NETWORK ANALYZER 8407A

OPERATING AND SERVICE MANUAL

Serial Prefix: 1144A

For serial prefixes above 1144A, a "Manual Changes" sheet is included with this manual. For serial prefixes below 1144A, see Appendix I.

Figure 7-12. Parts Location for Automatic Level Control Amplifier A13 (Change L, Serial No. 924-00130 and Below)

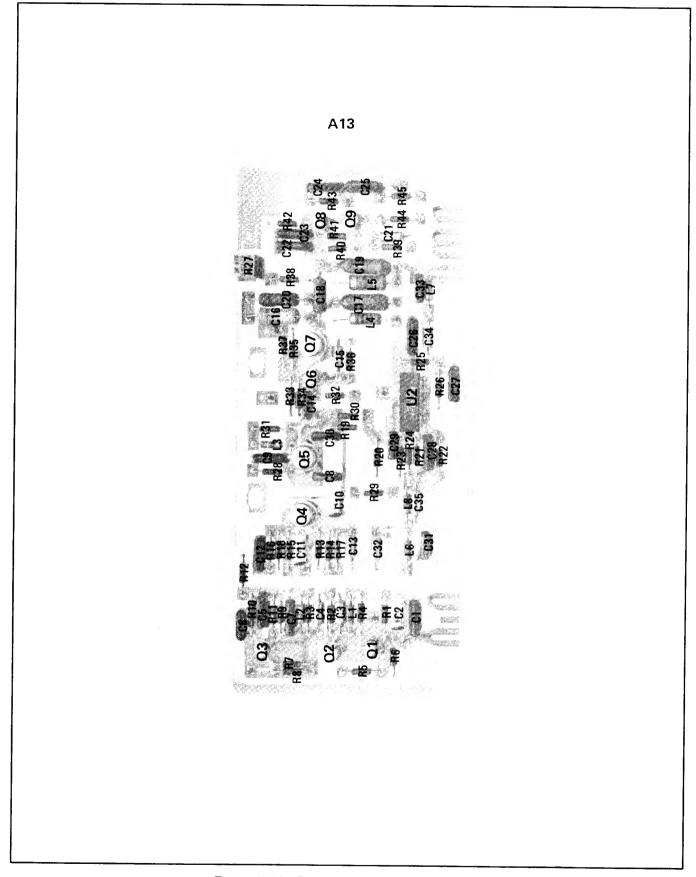
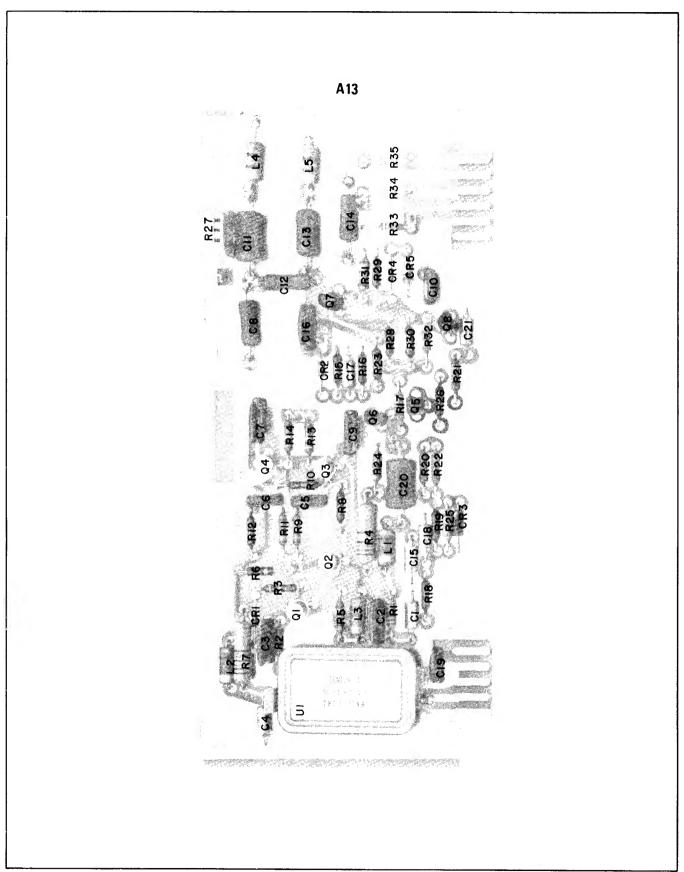
Change A13 to HP Part No. 08407-60003 and also change all of the associated A13 board components per the attached parts list. If it is necessary to replace A13, it should be replaced with HP Part No. 08407-60002 or 08407-60102 (rebuilt). At the same time A14 must be replaced with 08407-60123 or 08407-60107 (rebuilt).

Change parts location photo and circuit board schematic of A13 per attached Figure 7-12 and 7-13.

Figure 7-13. Automatic Level Control Amplifier A13, Schematic Diagram

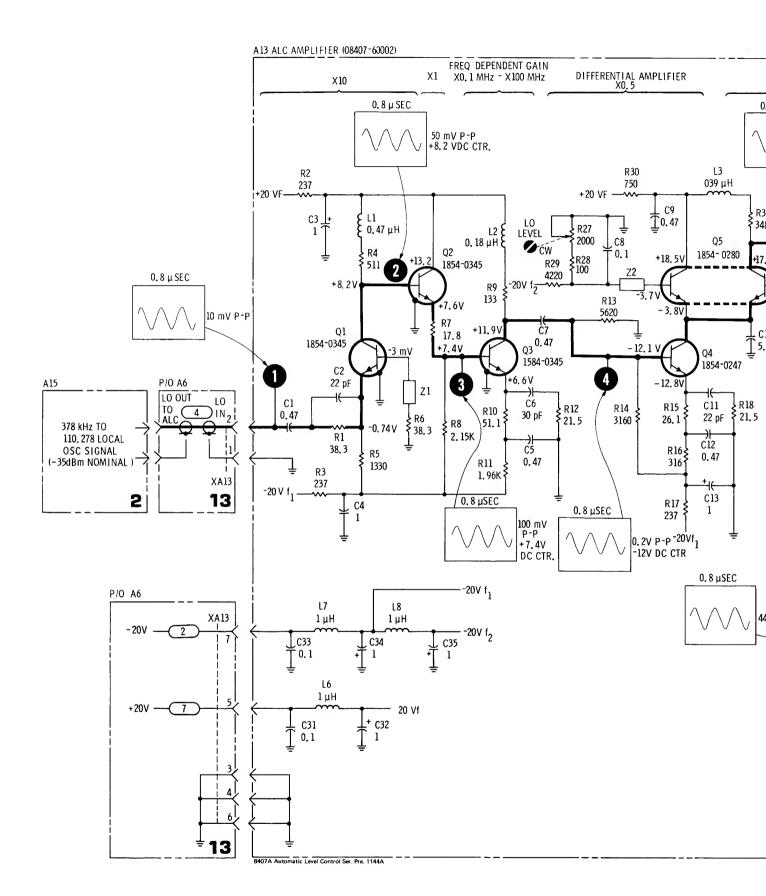
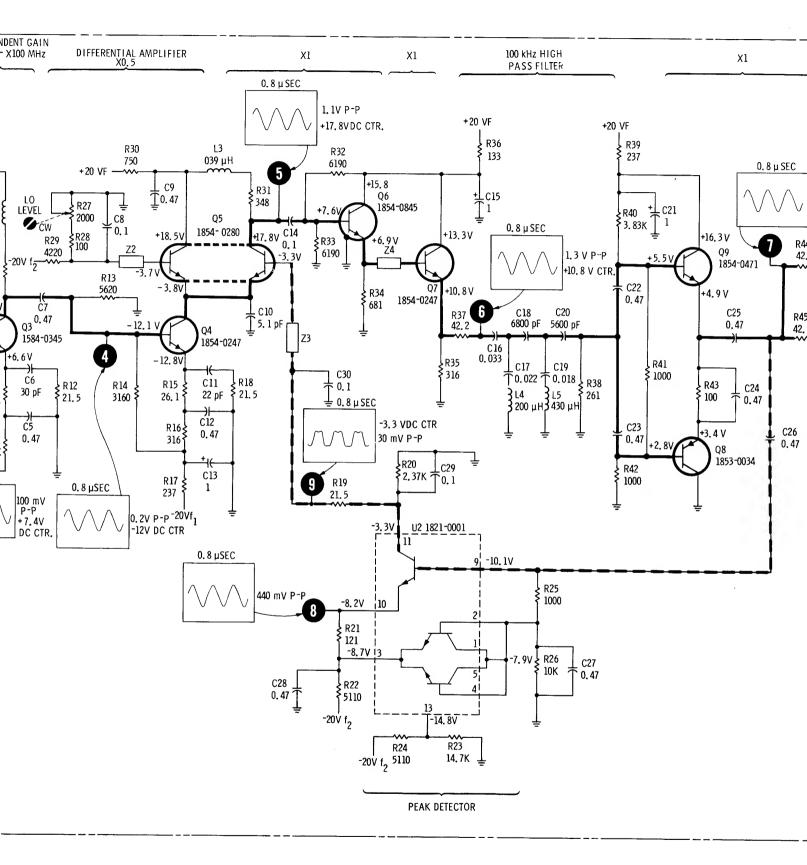
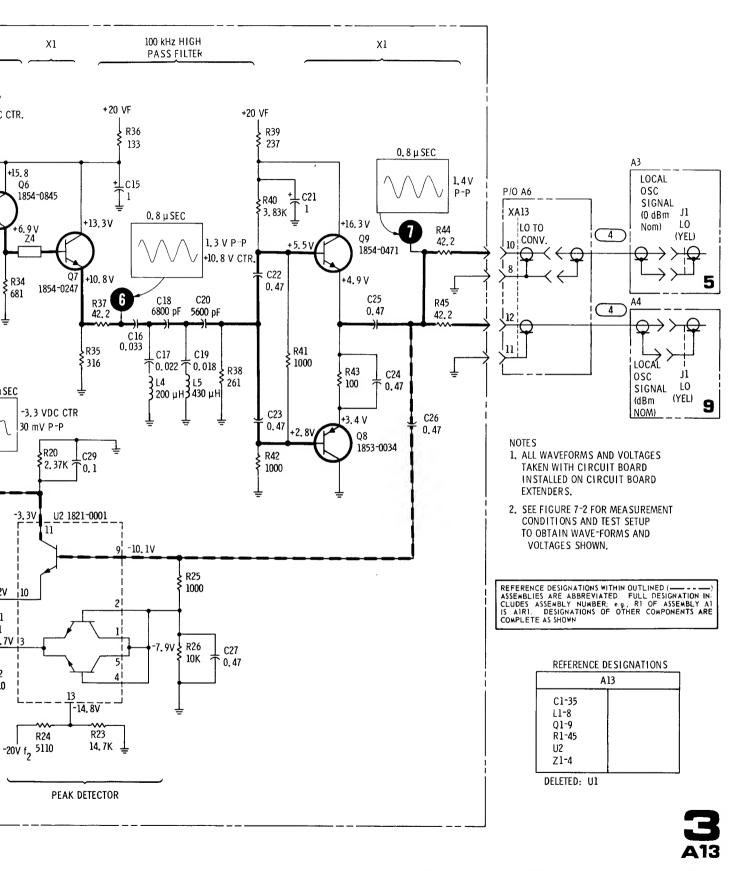
Page 7-13, Figure 7-13:

Change A13R28 to 511 OHMS.

Page 7-13, Figure 7-13:

Change A13L4 to 27 UH

Change A13L5 to 39 UH.

Figure 7-14. Parts Location for Phase-Locked Oscillator A14 (Change A, Serial No. 983-00446 thru 1103A00605)

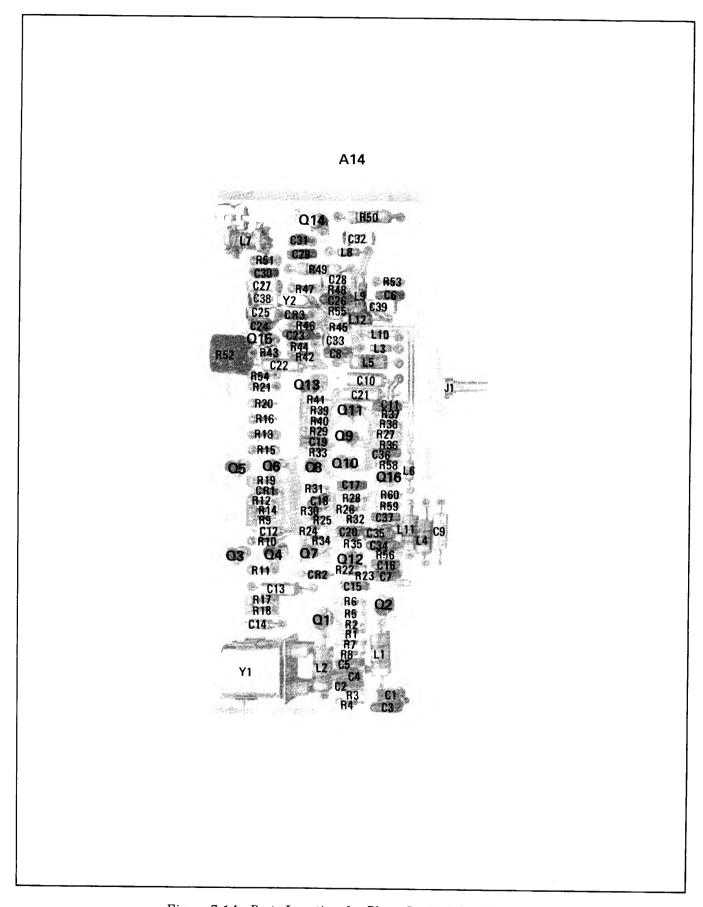
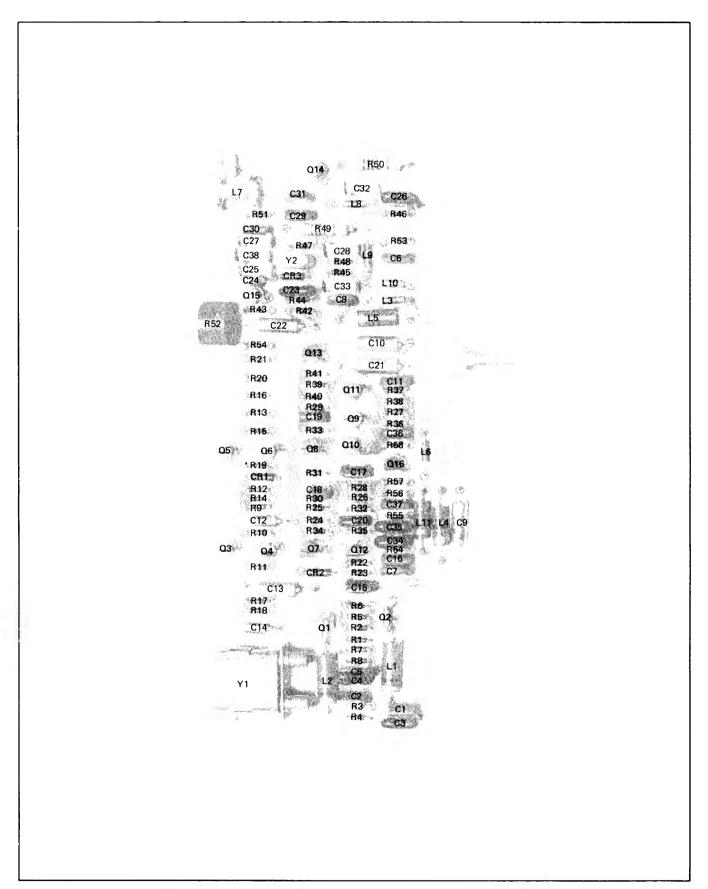
Page 7-15, Figure 7-14:

Replace Figure 7-14 in Section VII of Manual with Figure 7-14 (Change A) in this Appendix.

Figure 7-15. Phase-Locked Oscillator A14, Schematic Diagram

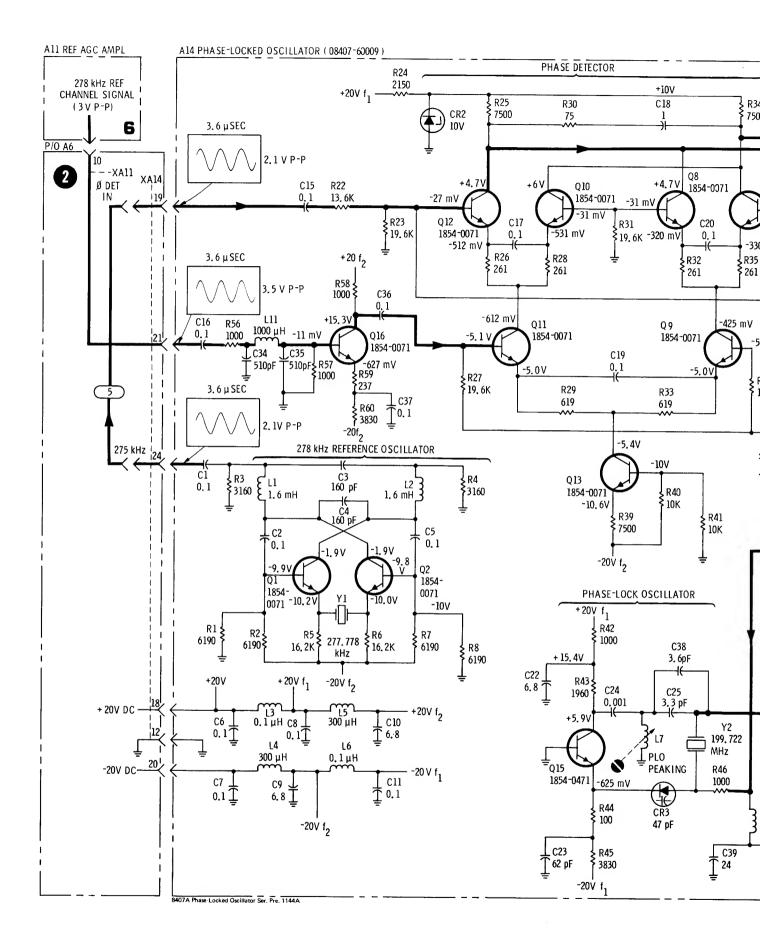
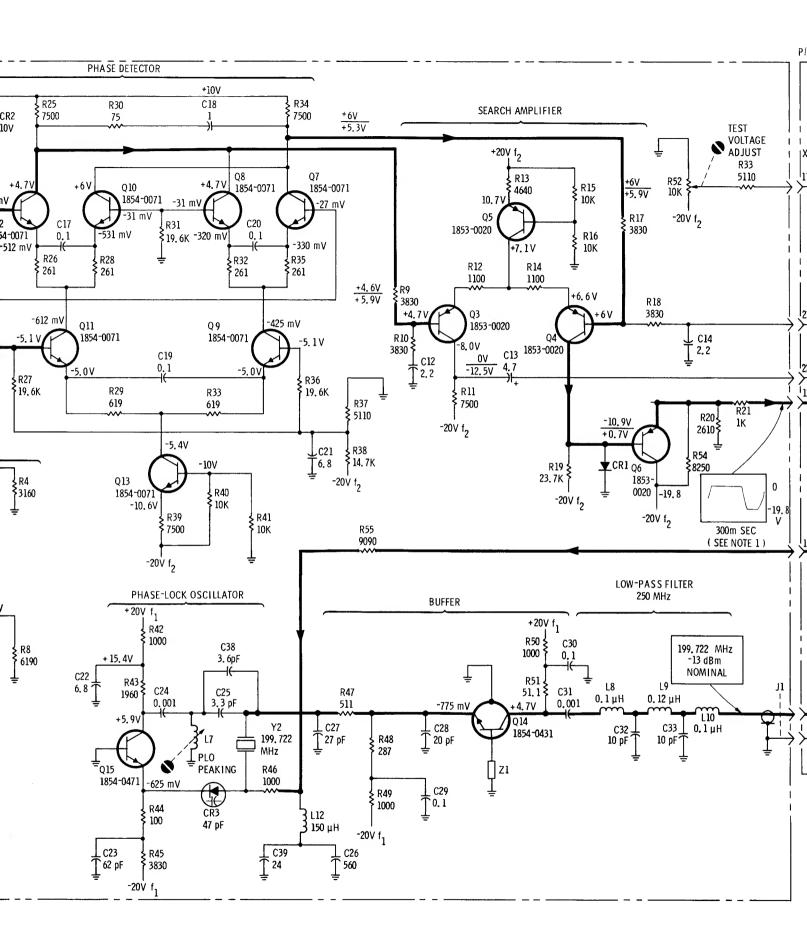
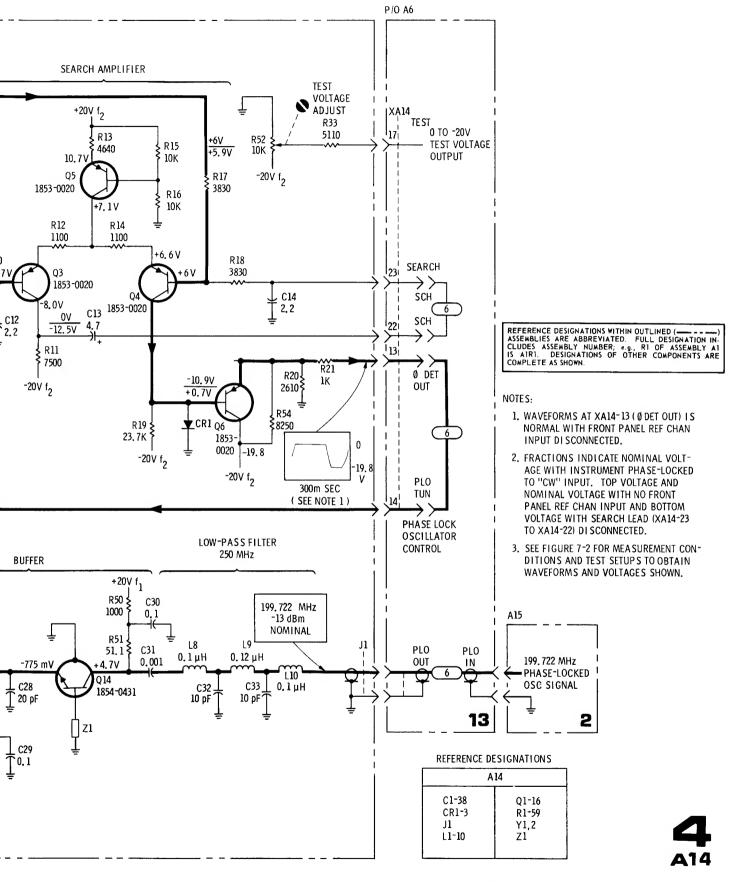
Page 7-15, Figure 7-15:

Change A14C26 to 180 pF

Delete A14C39

Delete A14L12 and jumper across connections

Change A14R21 to 10K ohm

Delete A14R55 and jumper across connections.

Figure 7-17. Reference Channel Converter A3, Schematic Diagram

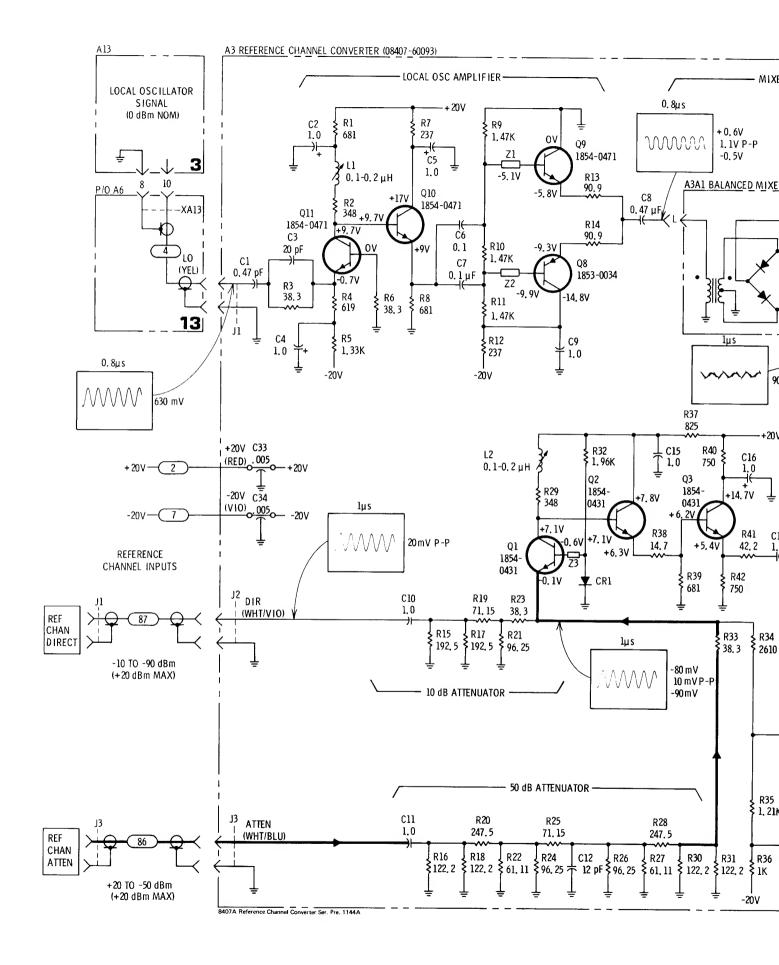
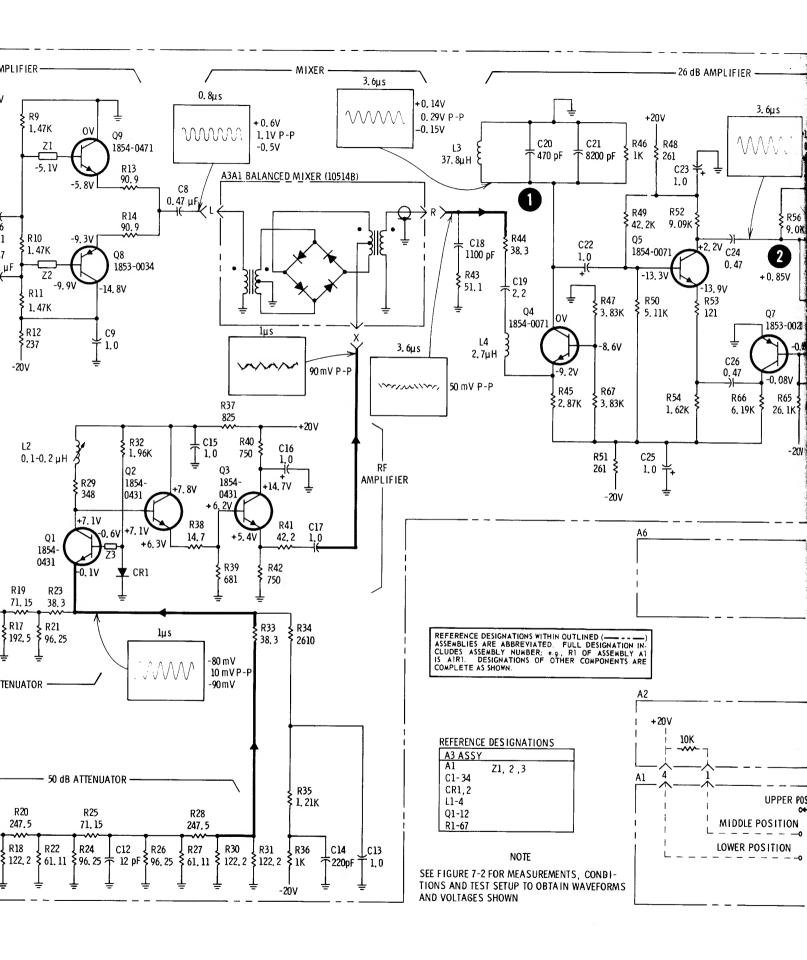
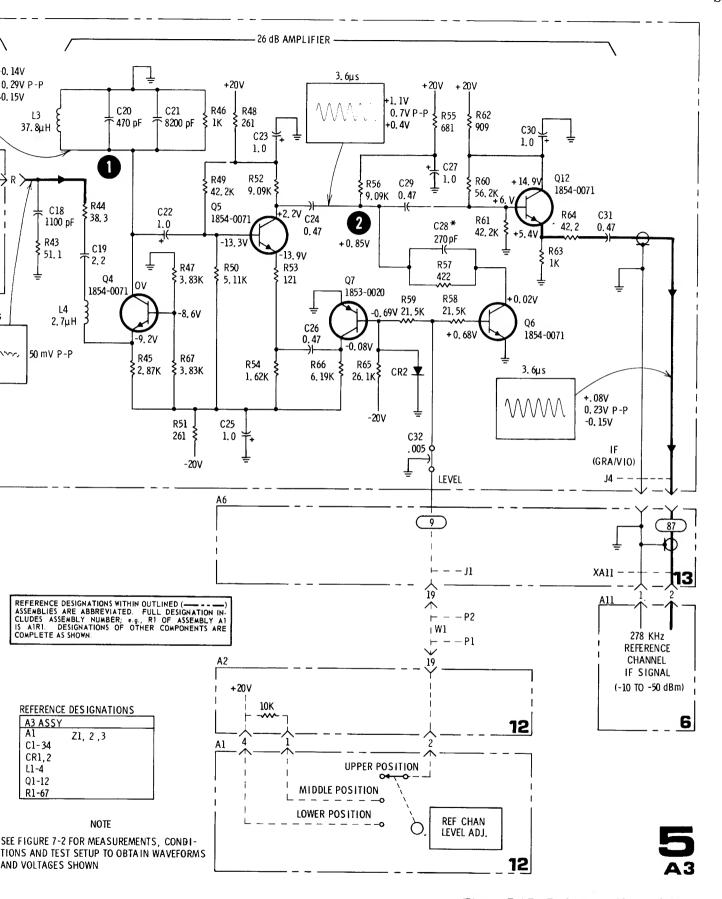
Page 7-17, Figure 7-17:

Change A3C28 to 330 pF.

Figure 7-19. Reference Channel AGC Amplifier A11, Schematic Diagram

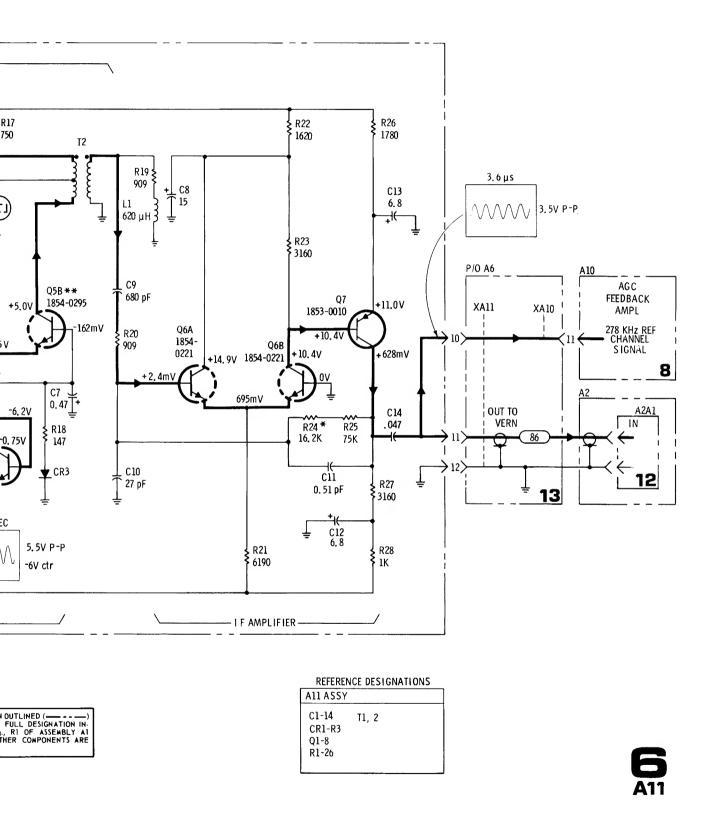
Page 7-19, Figure 7-19:

Change A11C12 and A11C13 to 15 UF.

Delete A11R29.

Figure 7-23. AGC Feedback Amplifier A10, Schematic Diagram

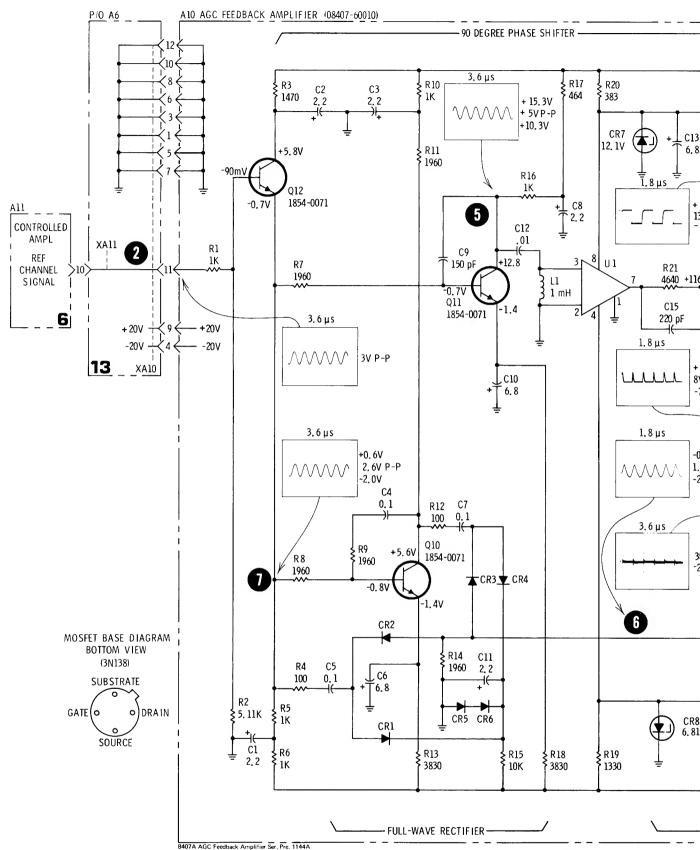
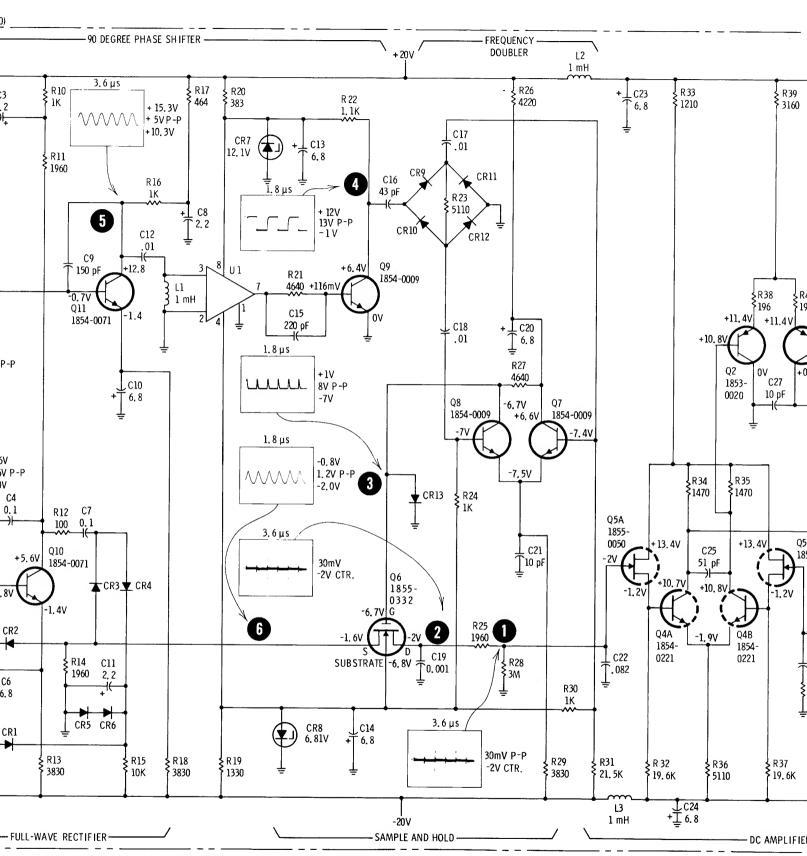
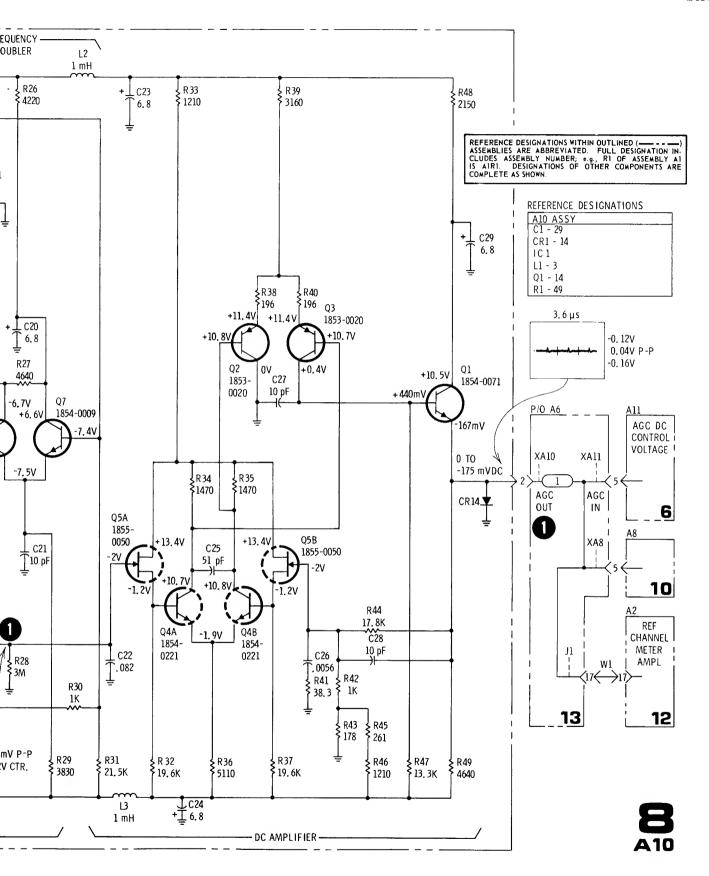
Page 7-23, Figure 7-23: Delete A10CR14.
